STATE OF UTAH
DEPARTMENT OF NATURAL RESOURCES
DIVISION OF OIL, GAS AND MINING

APPLICATION FOR PERMIT TO DRILL		1. WELL NAME and NUMBER GMBU 112-32-8-17
2. TYPE OF WORK DRILL NEW WELL <input checked="" type="checkbox"/> REENTER P&A WELL <input type="checkbox"/> DEEPEN WELL <input type="checkbox"/>		3. FIELD OR WILDCAT MONUMENT BUTTE

NEWFIELD PRODUCTION COMPANY
GMBU 112-32-8-17
AT SURFACE: NW/NW SECTION 32, T8S R17E
DUCHESNE COUNTY, UTAH

TEN POINT DRILLING PROGRAM

LOCATION LAYOUT EXISTING 4-32-8-17 PAD PROPOSED WELL: 112-32-8-17

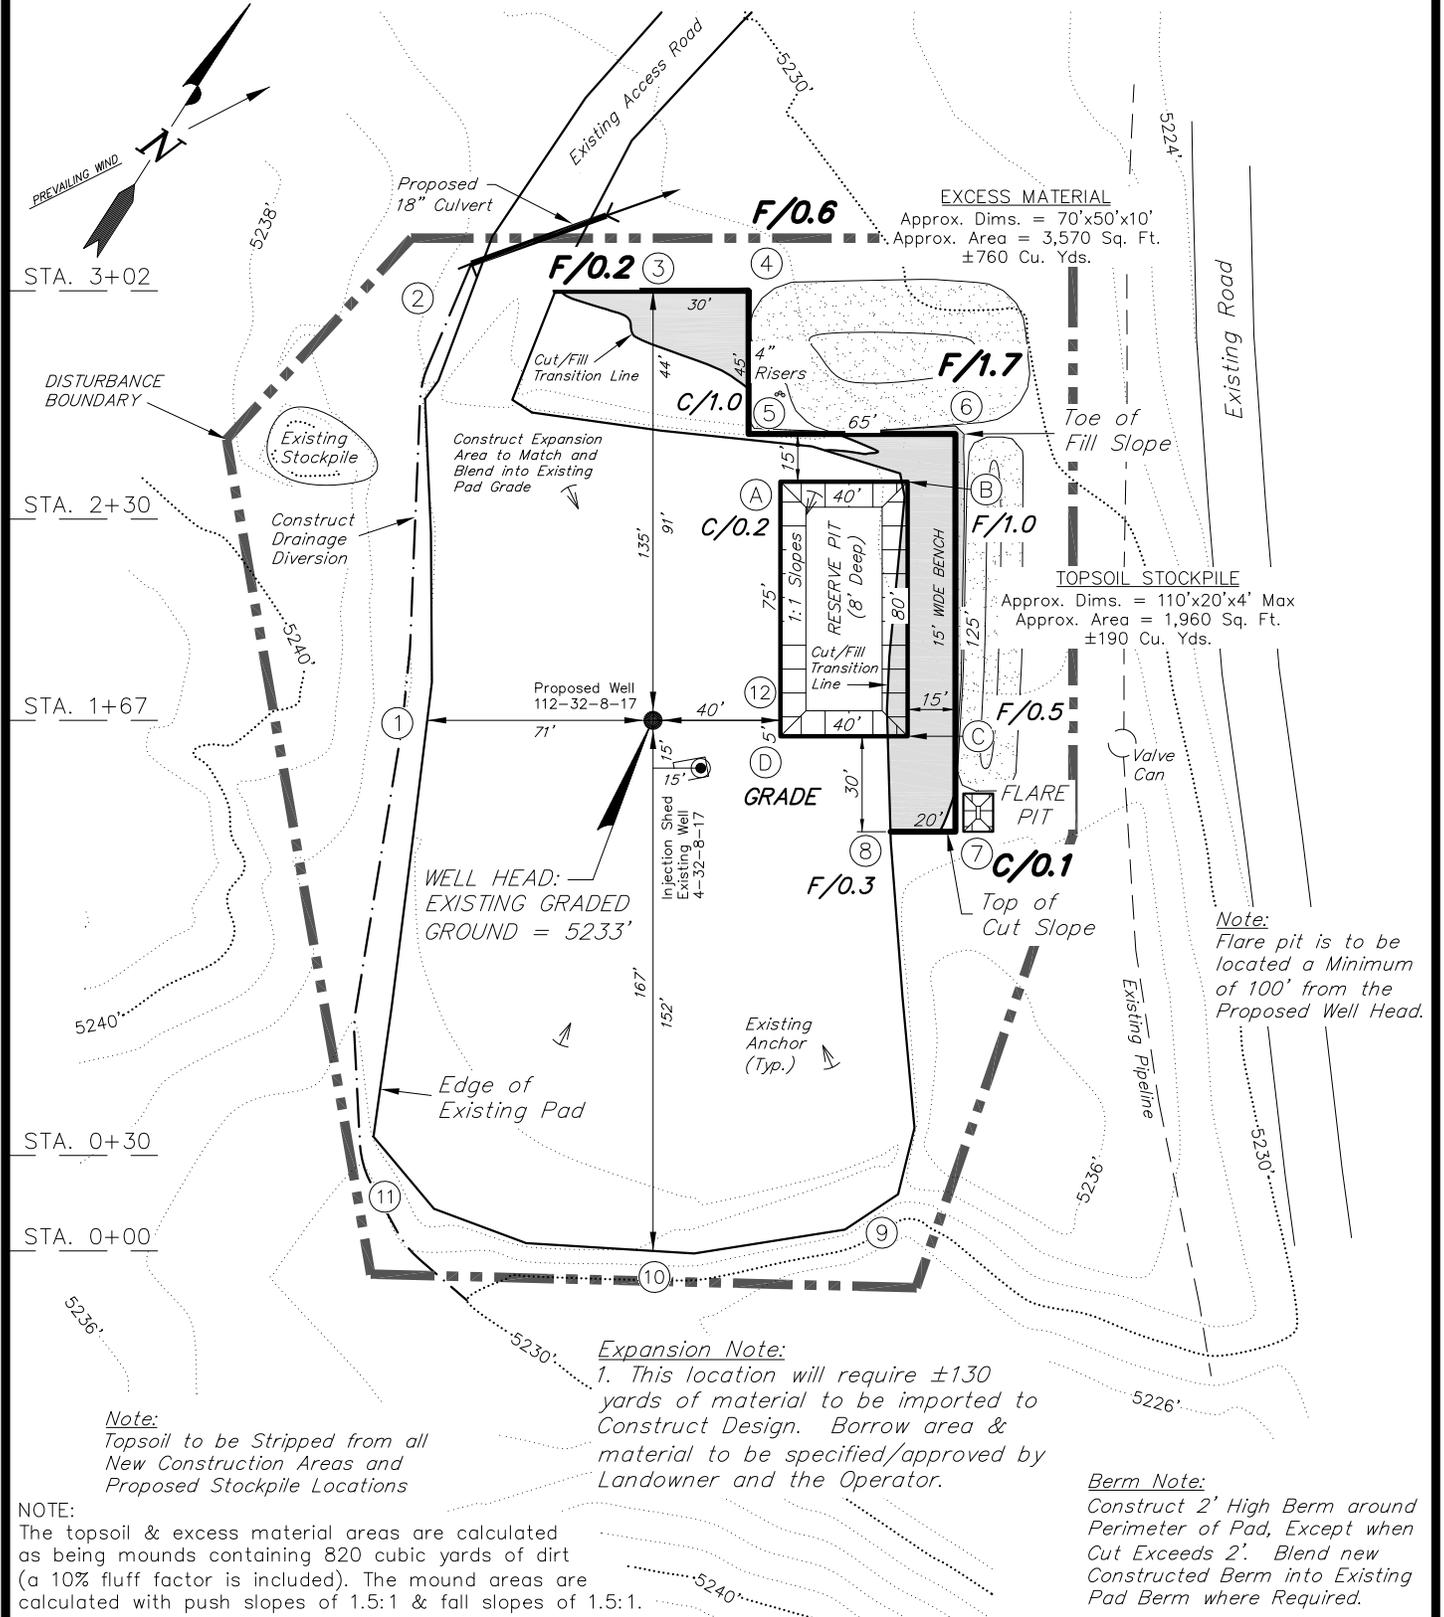
A reserve pit of 40 feet by 80 feet is planned. The reserve pit is planned in an area that is typically flooded throughout the year from persistent natural drainage patterns. Pit to be lined and bermed to protect from erosion and natural flows.

Usual construction standards of the Operator do not appear to be adequate for the proposed purpose as submitted. Plans lack measures to re route the drainage flows. Operator has not submitted plans for the protection of top soils.

Category	Condition
Pits	A synthetic liner with a minimum thickness of 16 mils with a felt subliner shall be properly installed and maintained in the reserve pit.
Surface	The well site shall be bermed to prevent fluids from entering or leaving the pad.
Surface	Drainages adjacent to the proposed pad shall be diverted around the location. New routes to be better planned and constructed.
Surface	The reserve pit shall be fenced upon completion of drilling operations.
